Flat Ground Floor, 27 Nassington Road (2026/0726/P)

Delegated Report (Members Briefing)		Analysis sheet		Expiry Date:	21/04/2026
		n/a		Consultation Expiry Date:	29/03/2026
Officer			Application Number		
Tony Young			2026/0726/P		
Application Address			Drawing Numbers		
Flat Ground Floor 27 Nassington Road London NW3 2TX			Refer to the draft decision notice		
PO 3/4	Area Team Signature	C&UD	Authorised Officer Signature		
Proposal					
Enlargement of rear black metal balcony and associated alteration to spiral staircase (retrospective).					
Recommendation	Grant Planning Permission				
Application Type	Full Planning Permission

Enlargement of rear black metal balcony and associated alteration to spiral staircase (retrospective).

Images 3 & 4 – existing & proposed rear elevations showing nos.25 & 27 (drawing extracts)

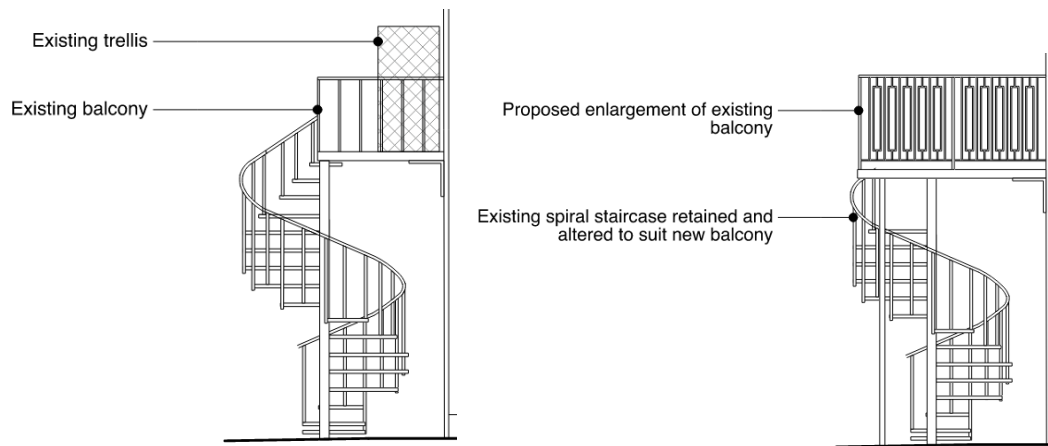
- 3.11 As a result of the proposal, the new balcony area measures approximately 2.1 metres in depth by 3.2 metres in width, resulting in an increase of approximately 0.6 metres in depth and 0.9 metres in width relative to the dimensions of the pre-existing landing space.
- 3.12 An enlargement of this kind is considered to constitute a modest increase to the pre-existing amenity space in context with the surrounding rear environment and is comparable in size and scale with several other balconies located along the rear terrace of houses, not least with the adjoining neighbouring property at no.25 (see Images 3 & 4 and 7 & 8 below for comparison).

- 4.7 This is evident regarding the relationship between no.25 and the host property when viewing Images 4 and 8 above which show the nearest upper ground floor and 1st floor windows in context with possible vantage points from the proposed enlarged balcony at the application site.

Images 5 & 6 – existing & proposed side elevations (drawing extracts)

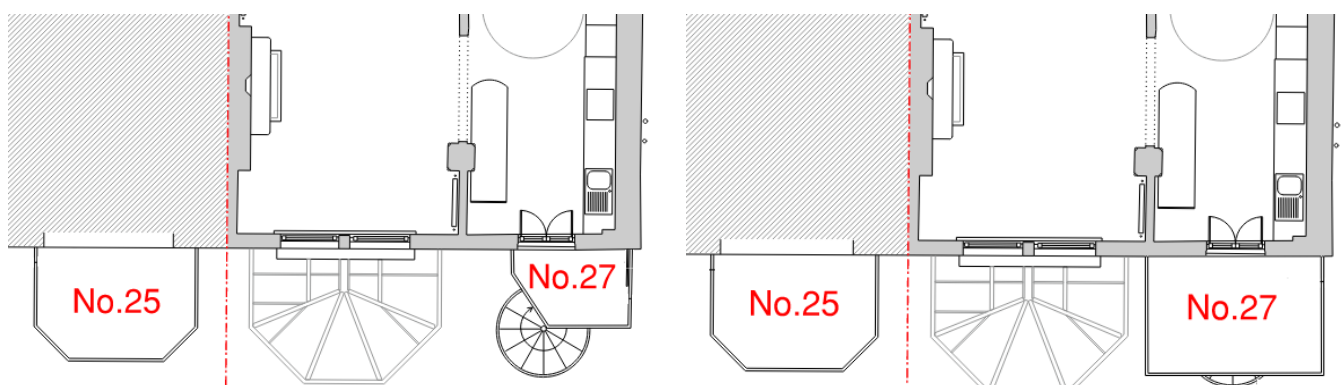
- 3.10 In this particular case, the proposals involve alterations which have already taken place to enlarge a rear landing above a spiral staircase at raised ground floor level, install replacement black metal railings around the new balcony space and associated minor alterations to part of the existing spiral staircase (see Images 3-6 below).

Images 7 & 8 – existing & proposed upper ground floor plans showing nos.25 & 27 (drawing extracts)

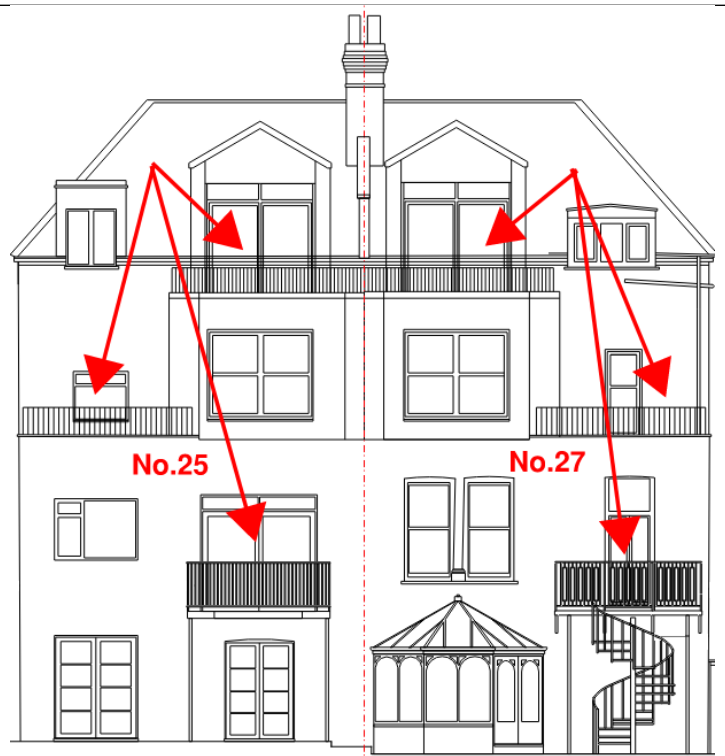
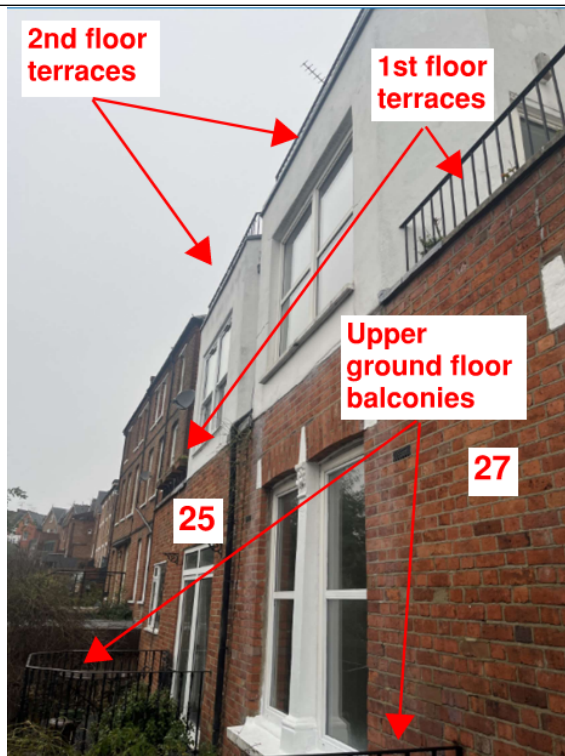
- 3.13 As such, the proportions of the proposed enlarged balcony largely replicate that which exists at the neighbouring property. The only difference being the general shape of the balcony platforms; this being more rectangular as proposed at the host property, while tapering off at the outermost edges at no. 25. However, while it is accepted that it is not necessary that the proposed balcony platform should match that at no. 25, it is nevertheless noted that this marginal difference in design is only recognisable in plan form, and that when viewed from the rear, it is not particularly evident.
